# Staff Report

## Site Plan Review and Minor Variances

SP-16-23 & VR-03-23

August 30, 2023

A2.1

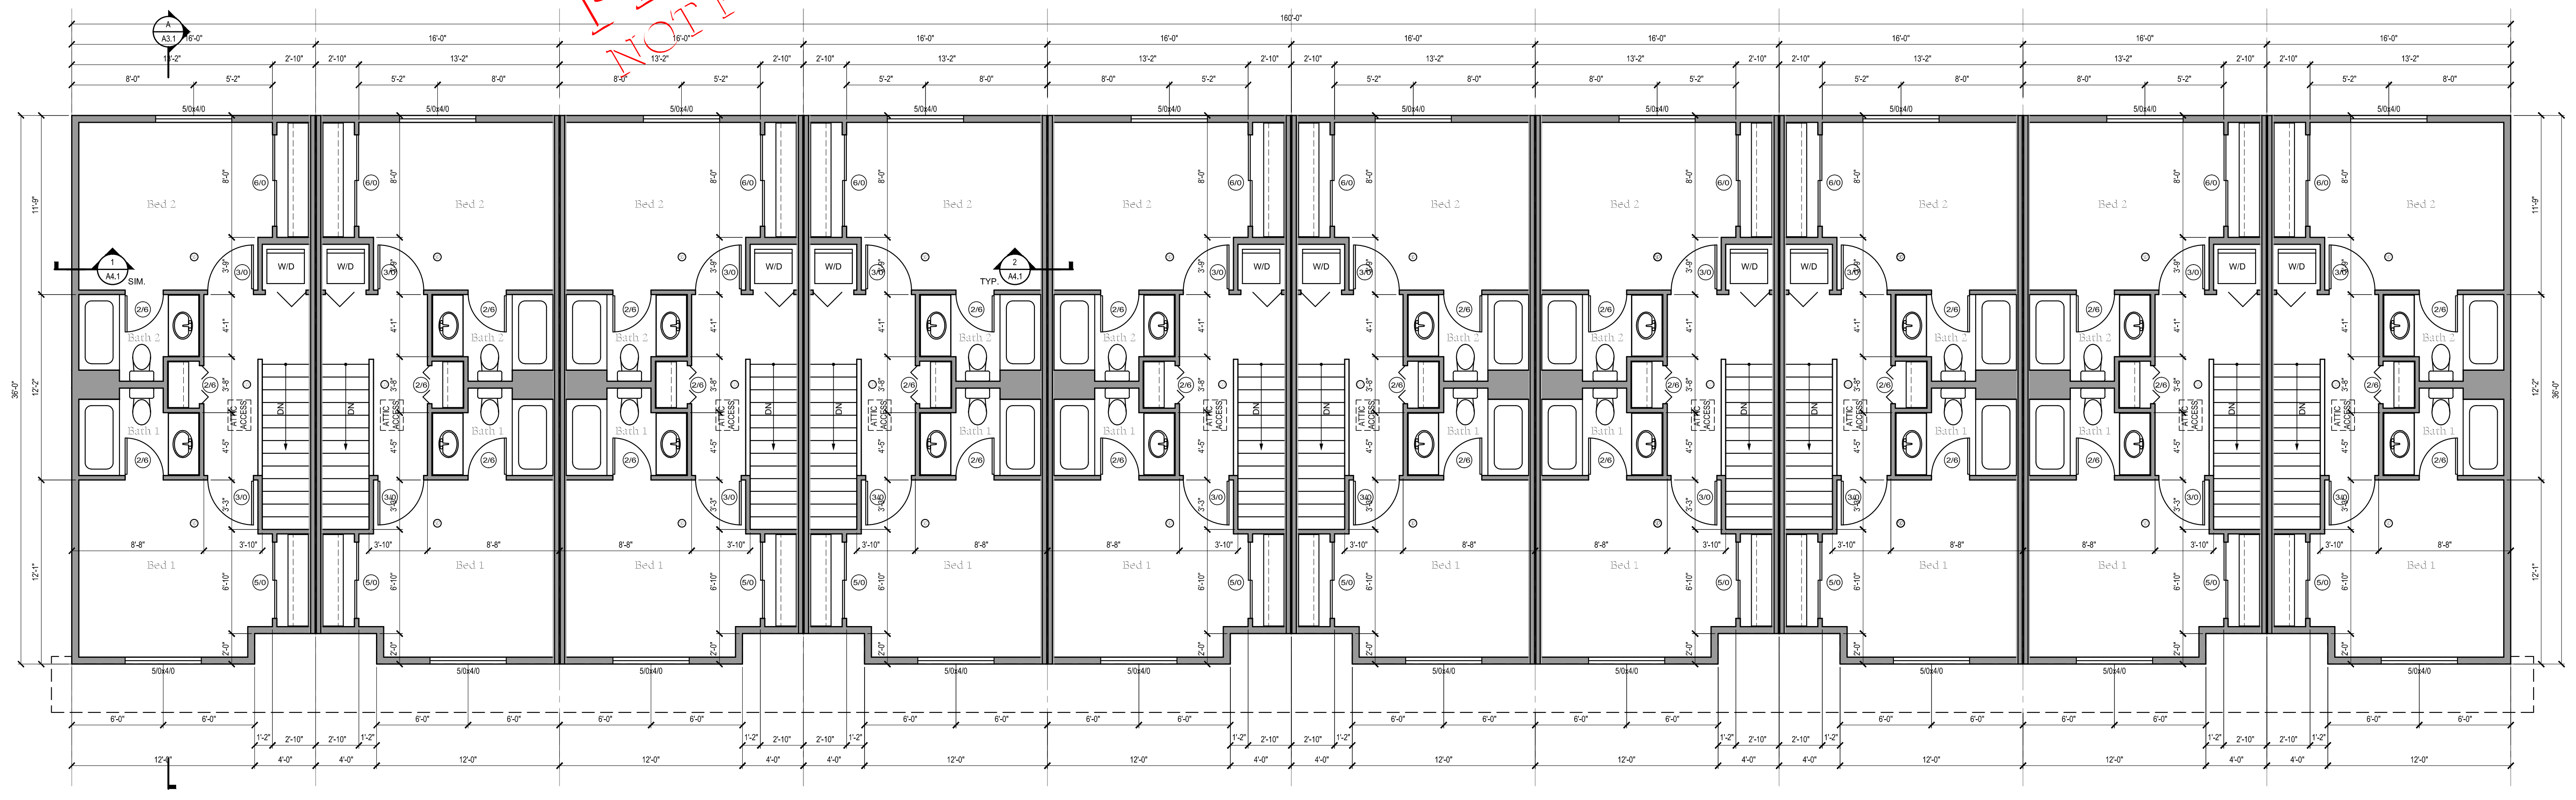
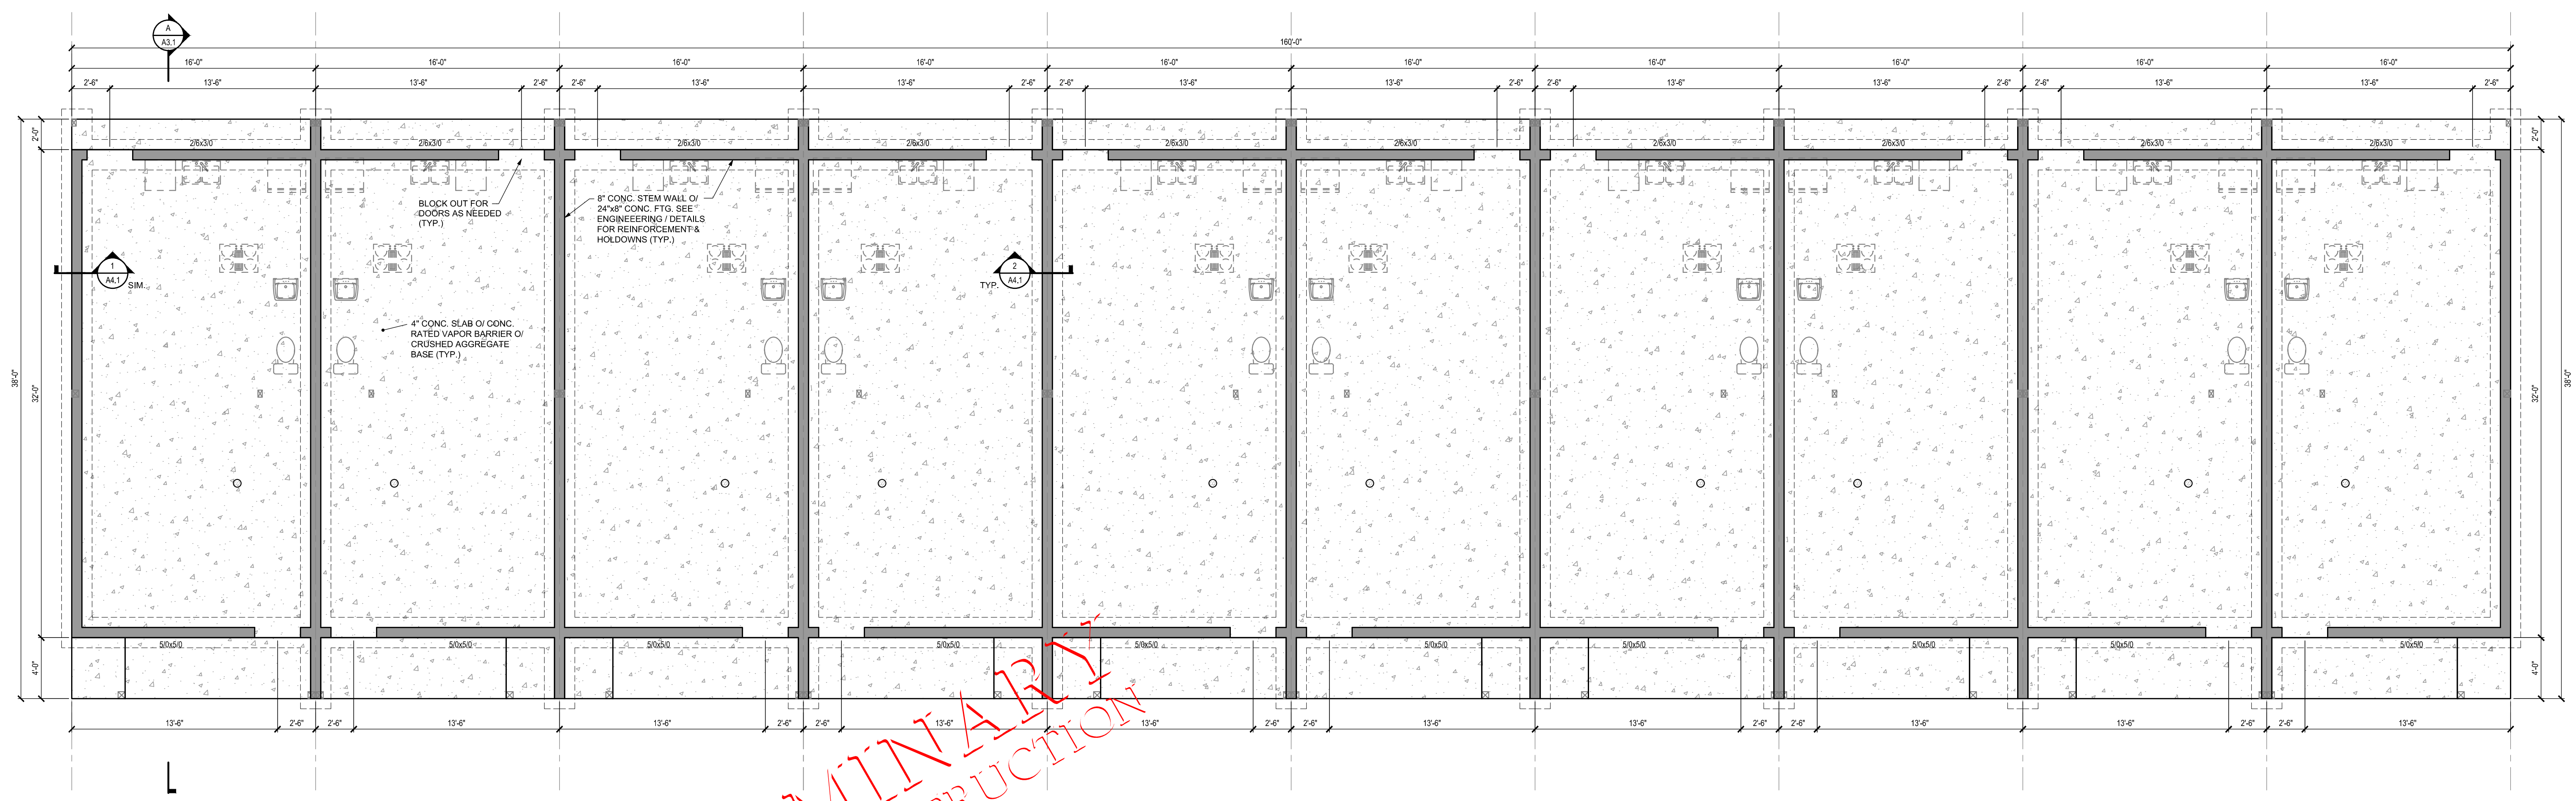
80 SQ FT PRIVATE SPACE, MIN 6 FT IN ANY DIRECTION,  
REQ'D PER T8.220-1 & 8.220(3), FENCED AREA BEHIND UNITS?  
SHALL BE DESIGNATED ON SITE PLAN

SHEET TITLE: **FLOOR PLAN**  
CLIENT: **3LIFESTYLE HOLDINGS, LLC**

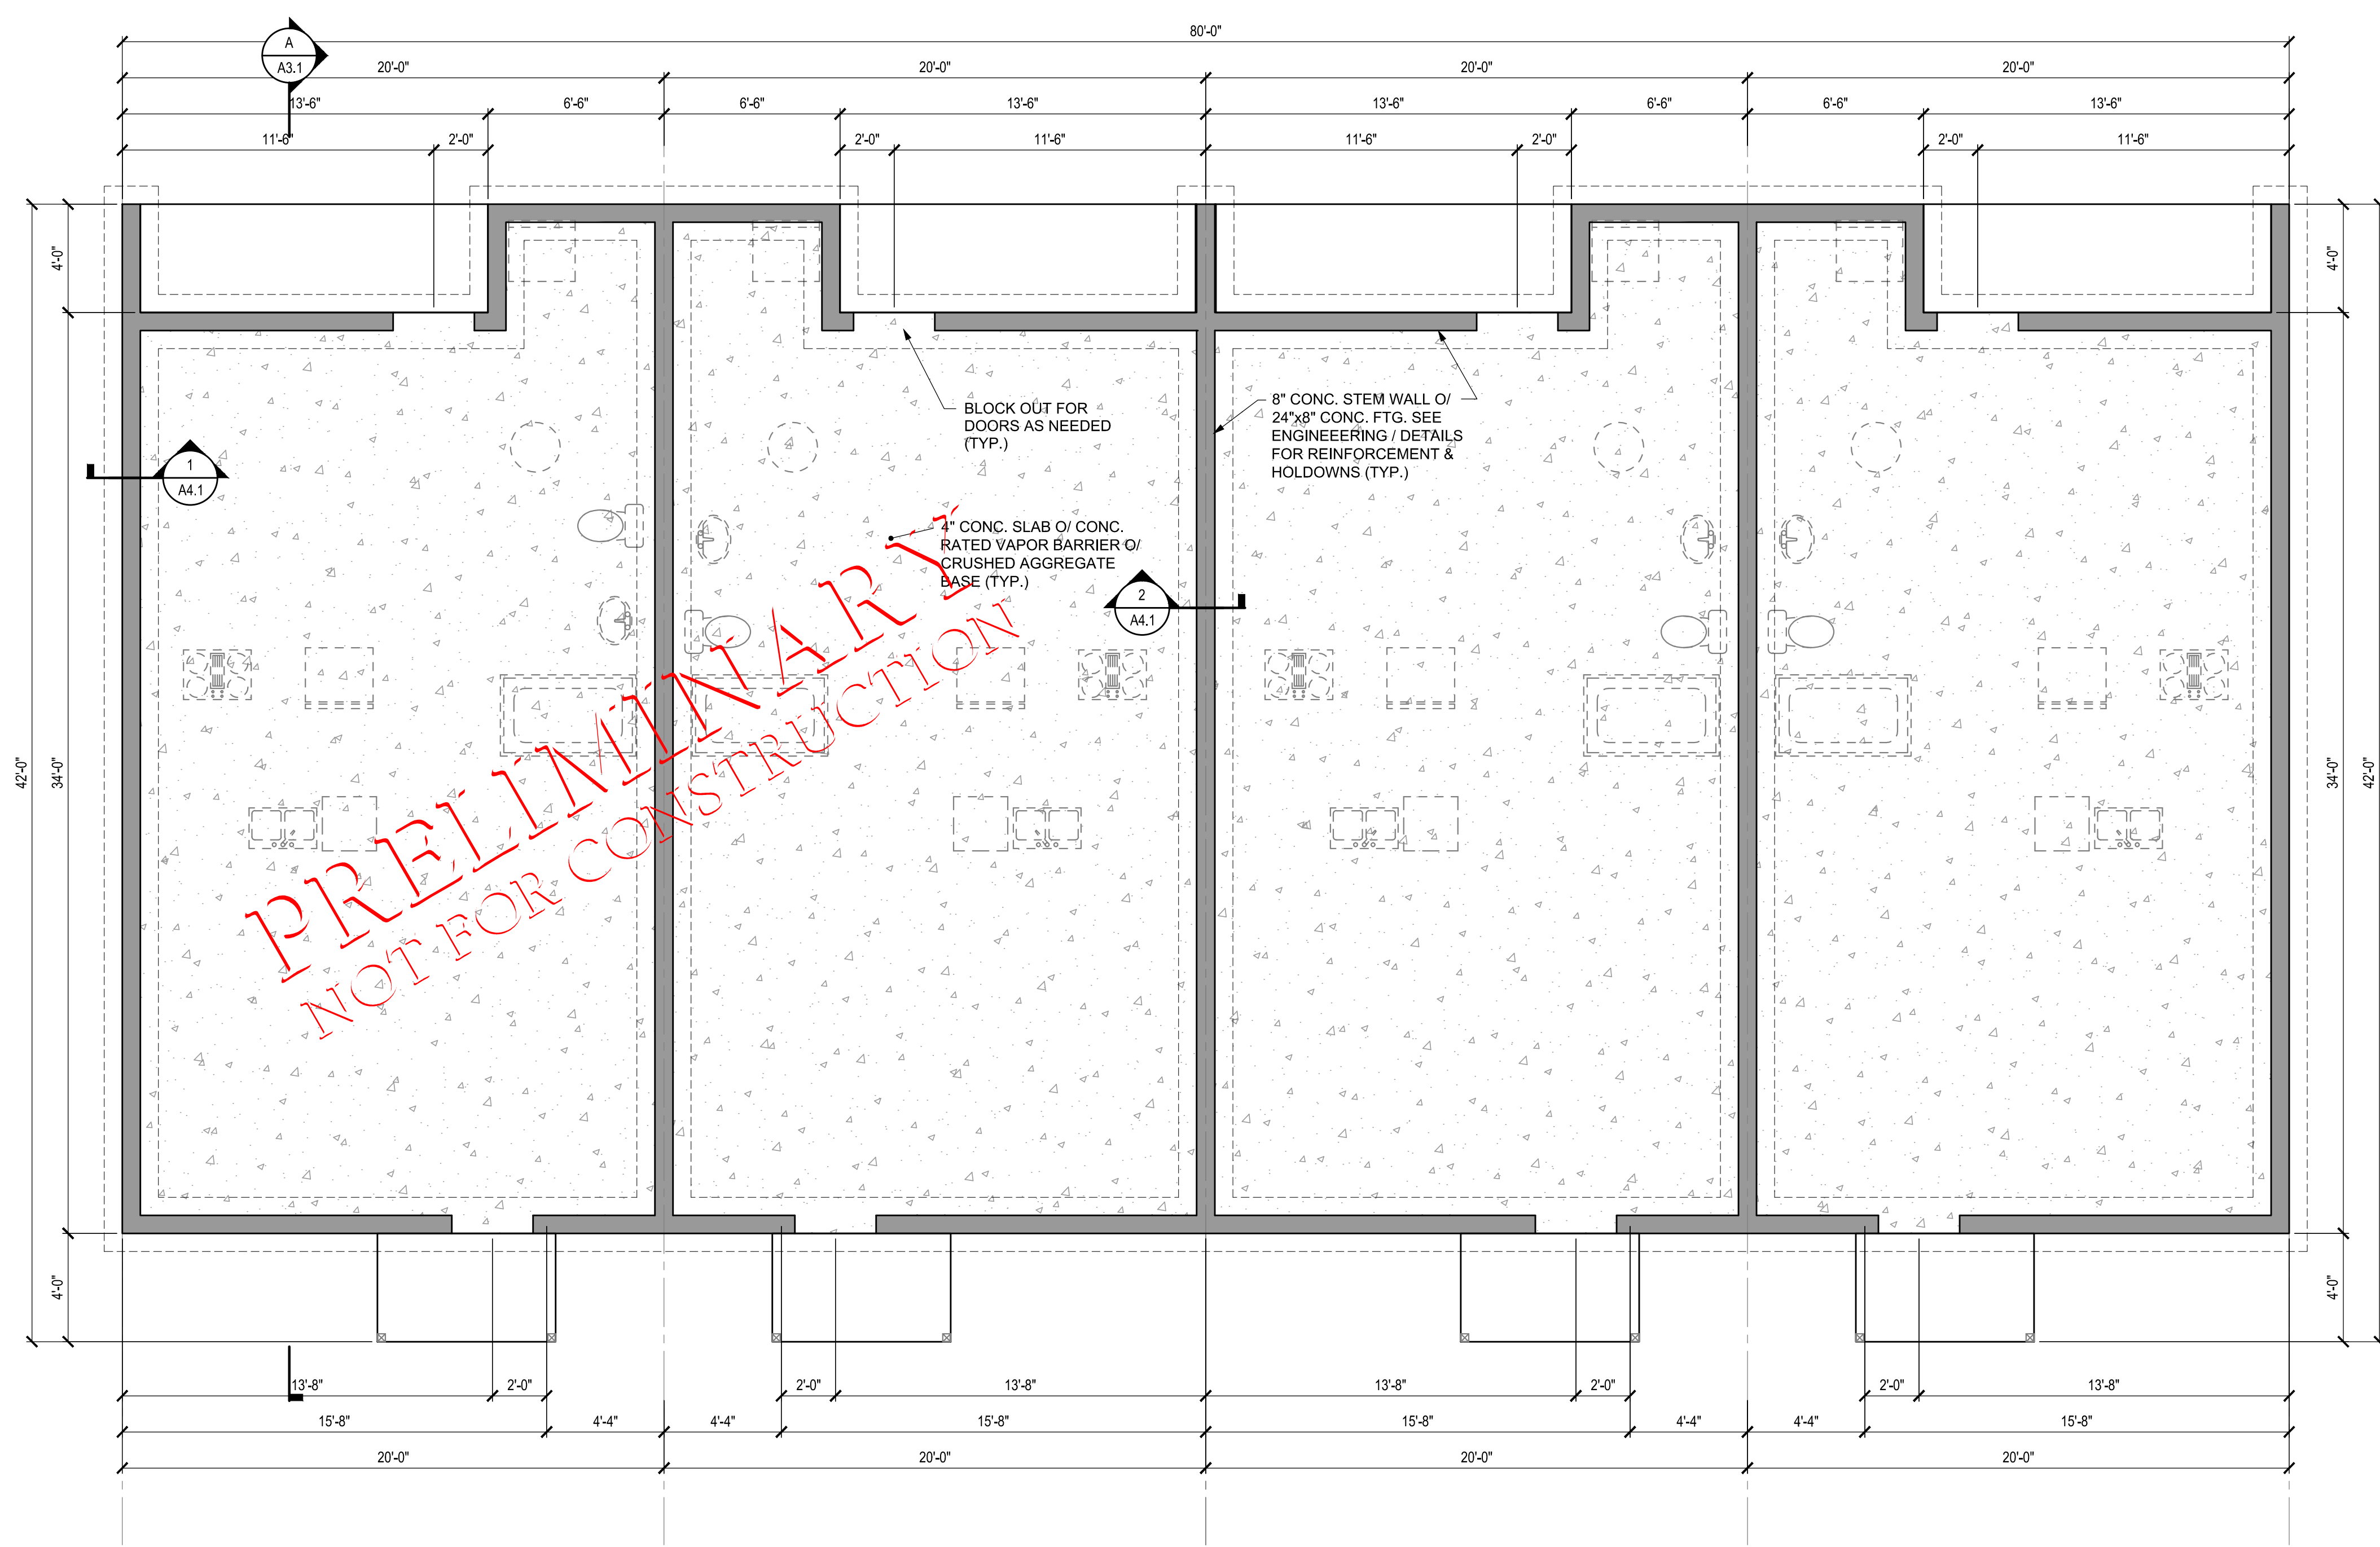
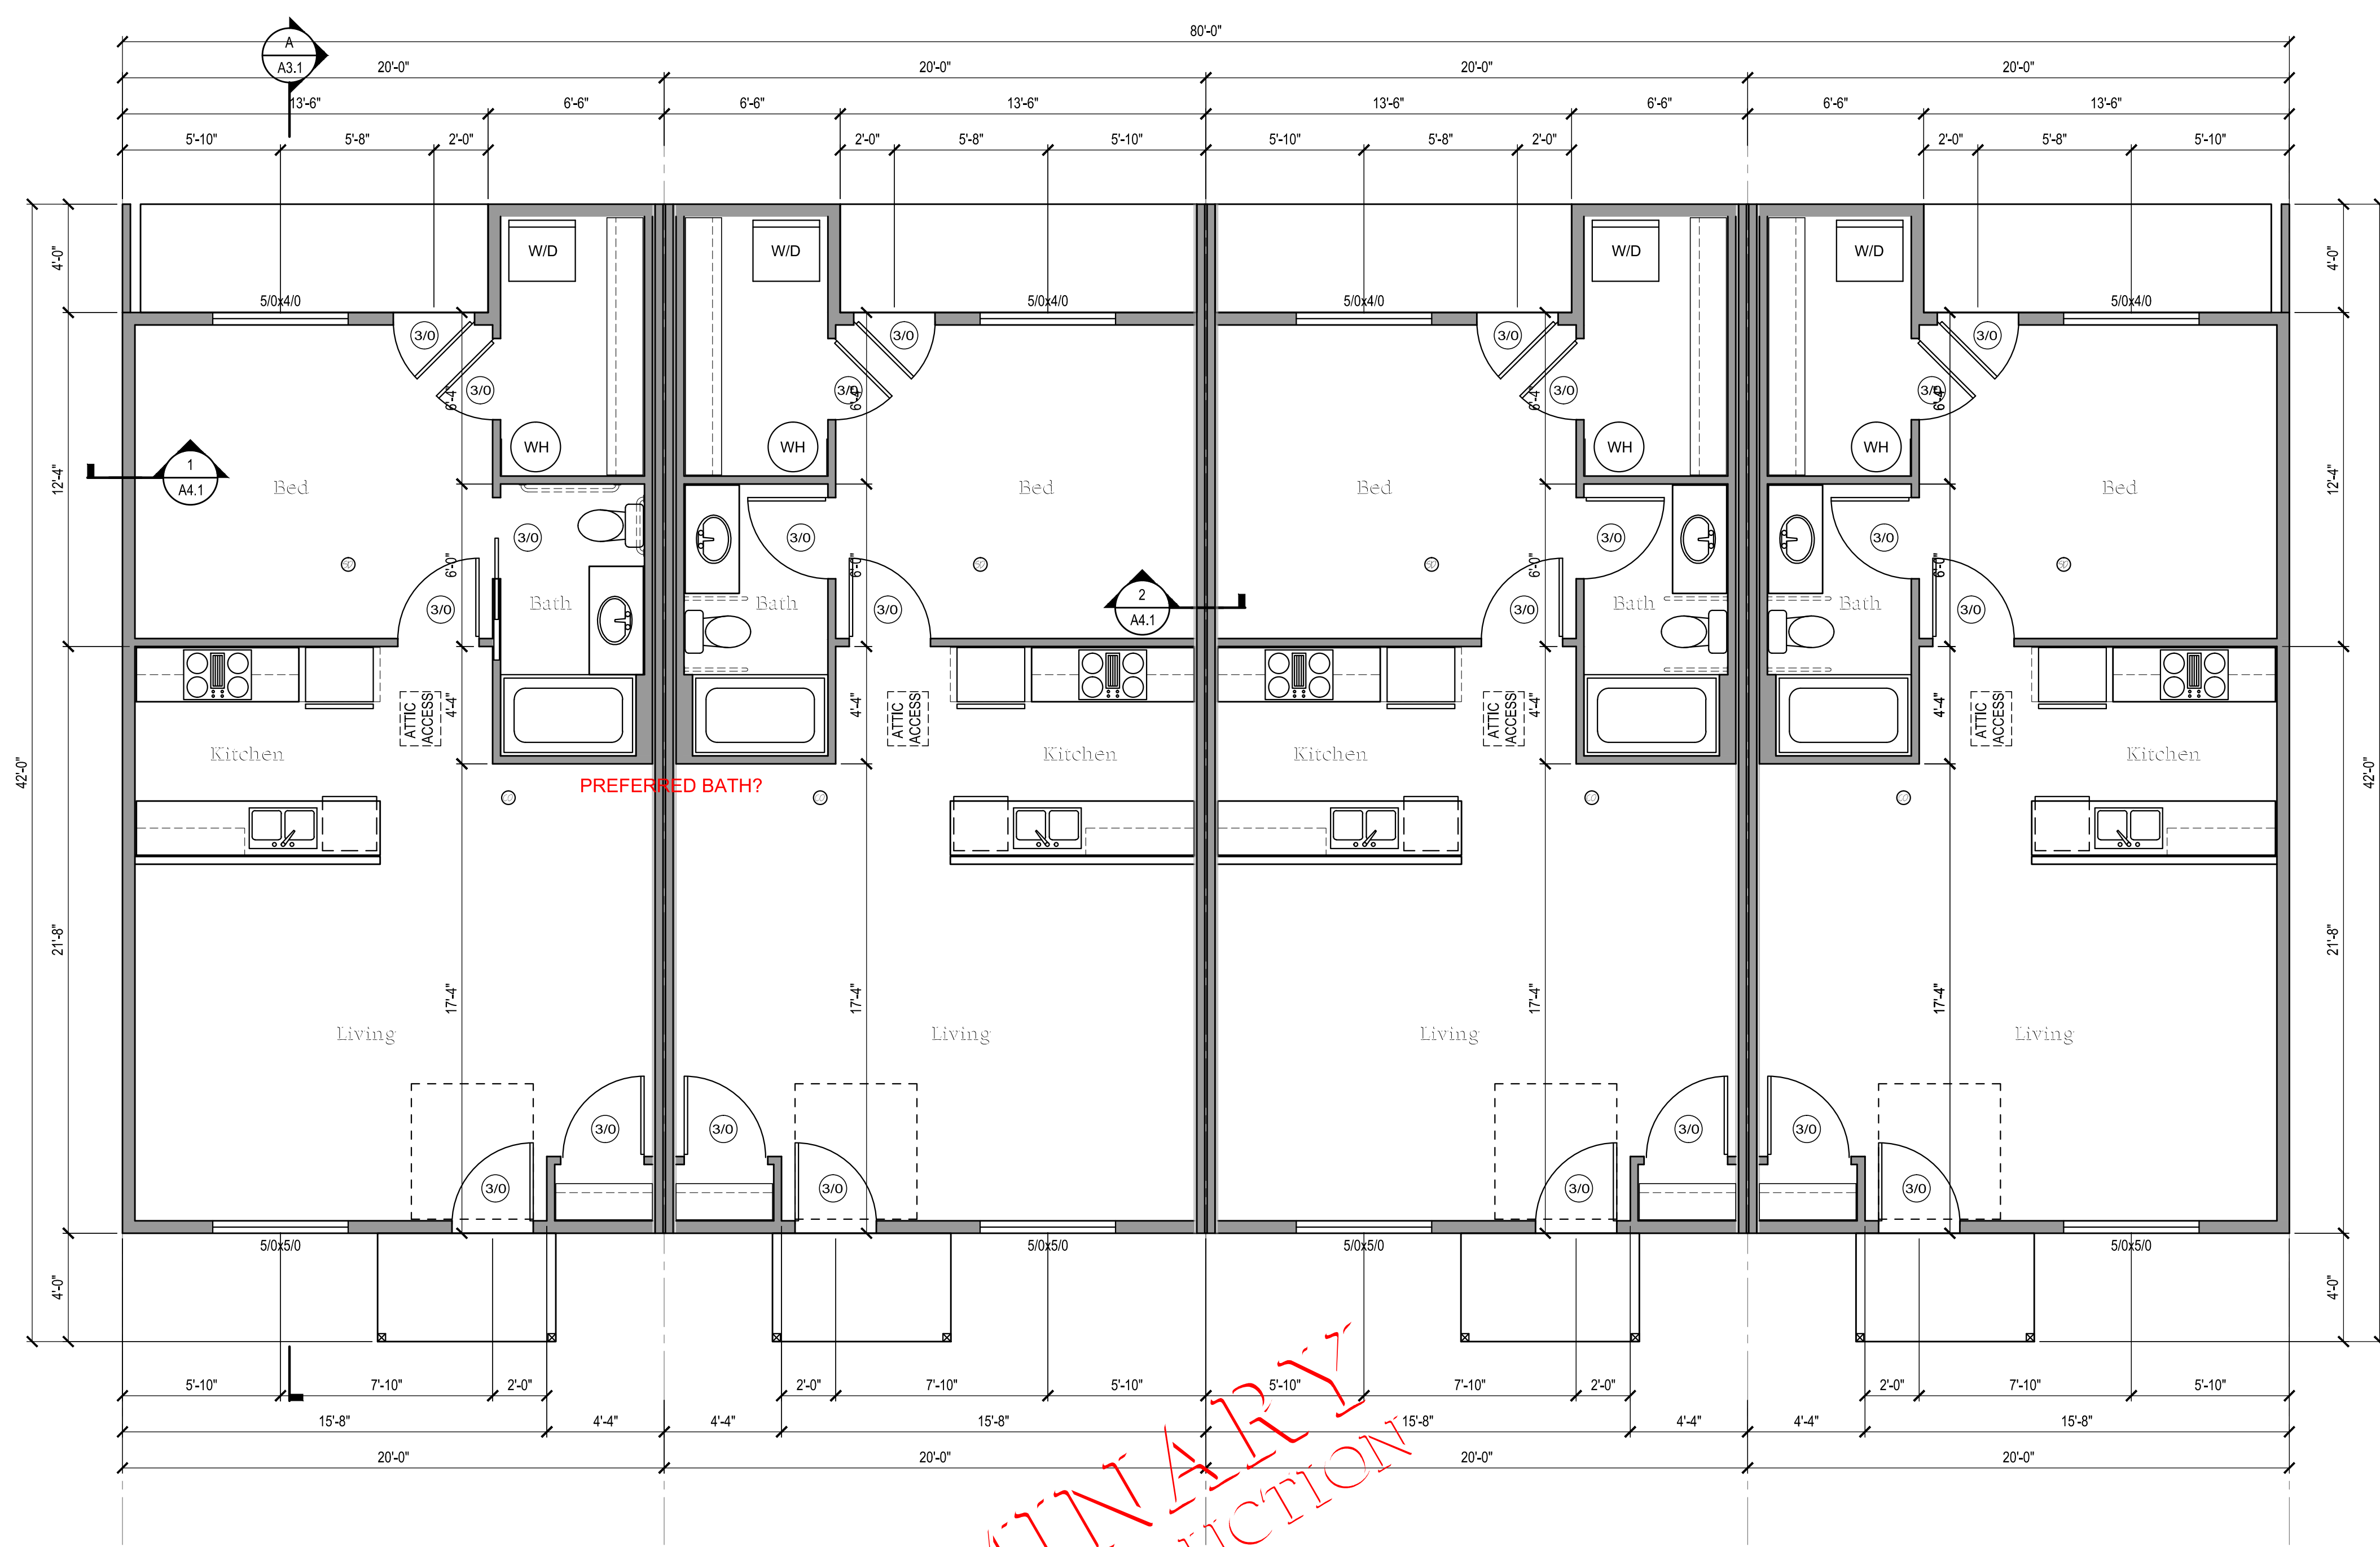
80 SQ FT PRIVATE SPACE, MIN 6 FT IN ANY DIRECTION,  
REQ'D PER T8.220-1 & 8.220(3), FENCED AREA BEHIND UNITS?  
SHALL BE DESIGNATED ON SITE PLAN
